DELEGATED APPLICATION REPORT

App Ref: PL/25/0167 Householder planning permission

Address: 16 JEFFERSON CLOSE, EMMER GREEN, READING, RG4 8US

Proposal: Single Storey Rear Extension and Internal Alterations

Drawing no: FD/452/624-Rev B-Proposed Elevations, not dated

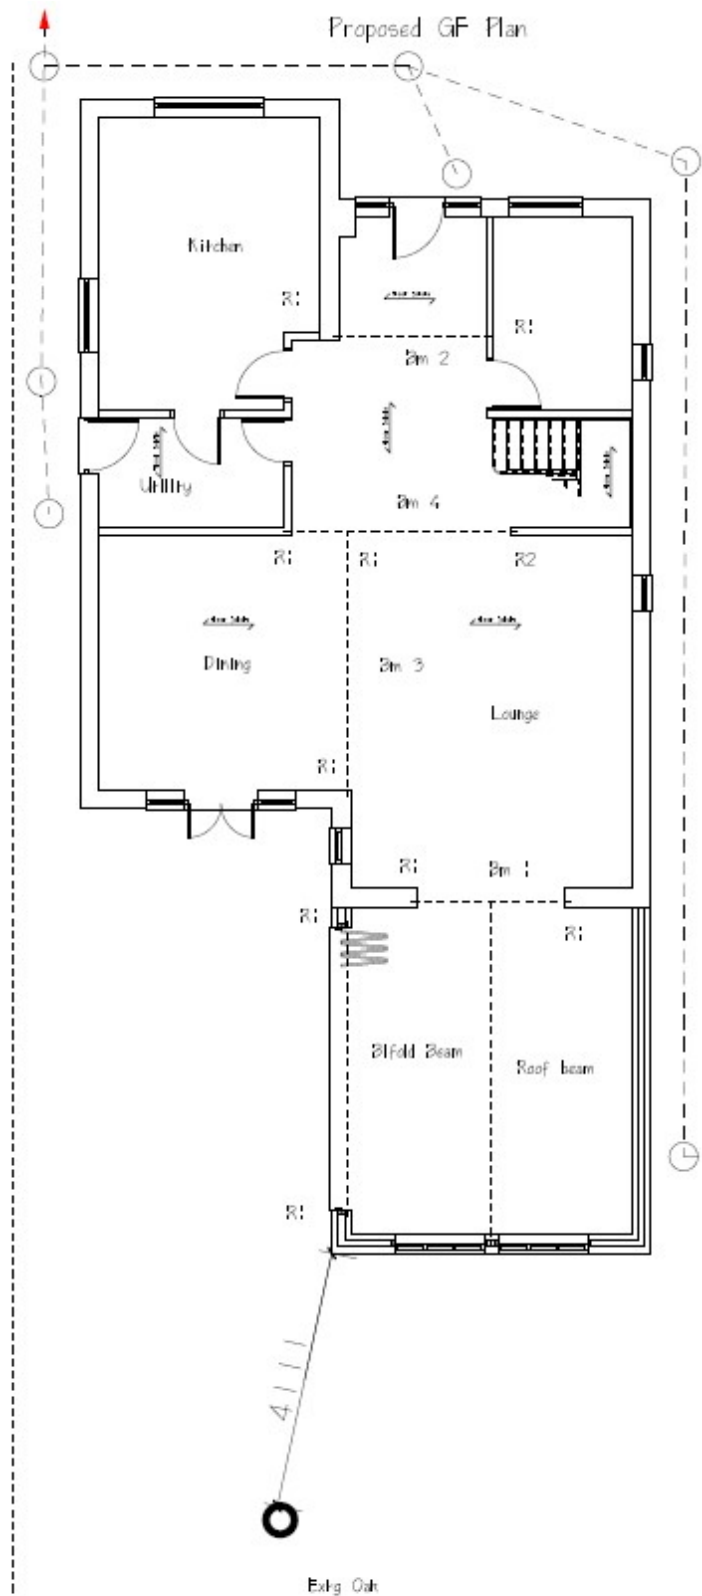
The proposed development by virtue of the single storey and design is considered acceptable in terms of appearance, however, the proposed development will consequent future pressures to prune or fell a mature English Oak tree. The proposed development is therefore detrimental to amenity and contrary to Policies H9 and CC7 and CC8 of the Reading Borough Local Plan 2019.

Structures should be located outside of Root Protection Areas (RPA) however, the proposed development is within the (RPA) of Tree T1 - English Oak. The Arboricultural Implications Report (SJA

trees) Tree Protection Plan (TPP) implies all roots of any size found can be cut - this is unacceptable and contrary to policy.

The proposed development is sited beneath the canopy of T1. The Arboricultural Implications Report (SJA trees) justifies this. However, this development will put pressures on the pruning of T1 which is unacceptable and contrary to policy.
